Technical Service Bulletin

93 Update OBC software when replacing HV wiring harness for charging socket

93 23 05 2070110/2 May 8, 2023. Supersedes Technical Service Bulletin Group 93 number 23-03 dated April 25, 2023, for reasons listed below.

Model(s)	Year	VIN Range	Vehicle-Specific Equipment
e-tron quattro	2019	All	Not Applicable
e-tron Sportback quattro	2020

Figure 1. High-voltage wiring harness for charging socket.

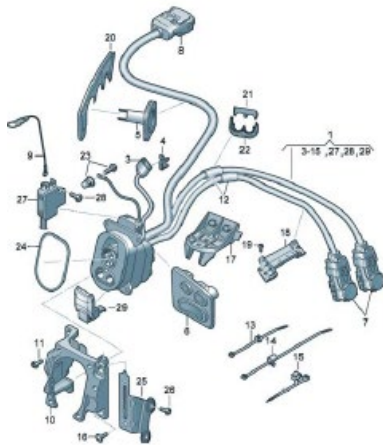
The High Voltage Wiring Harness for the charging socket UX4 or UX5 is replaced as part of any repair work (Figure 1).

The charging socket was modified in production.

From Q2 2020, only the new-generation high-voltage wiring harness for the charging socket is fitted in production vehicles.

It is essential to check the part number of the removed original high-voltage wiring harness and of the new replacement high-voltage wiring harness.

If the high-voltage wiring harness for the charging socket is replaced as listed in Table 1.2, an SVM code will need to be performed *and a replacement test plan performed*.

1. Follow all instructions in TSB 2011732: *00 Software Version Management (SVM), operating instructions*.
2. Update the On-Board Battery Charger (J1050) using the SVM action code as listed in the table below, if necessary:

- **Using the latest ODIS version, start diagnostics via Guided Fault Finding -> “Select own test”.**
 - 00C6 – High-voltage battery charger – J1050.
 - 00C6 – High-voltage battery charger, functions.
 - C6 – Replace the control module.
- After the update, the basic setting of the parking brake must be performed.
